Re: Review of Proposed First-Floor Framing Reinforcement — *416 Victoria Hills Drive South, Fuquay-Varina, NC 27526*

*Detail 1 – Repair Schematic
(Provided by Tar Heel Basement Systems)*

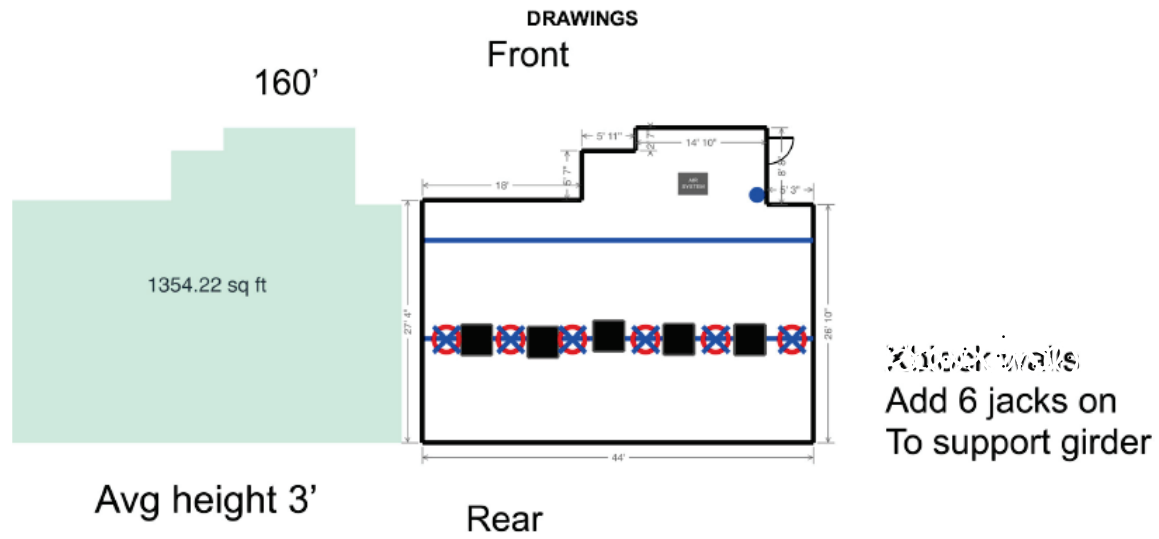
1. Reinforce each girder bay using an IntelliJack support on a well-compacted 18"x18"x18" gravel footing. Jacks should be located within the middle 1/3 of each girder span and at the approximate locations shown in the attached repair schematic (*see detail 2*).
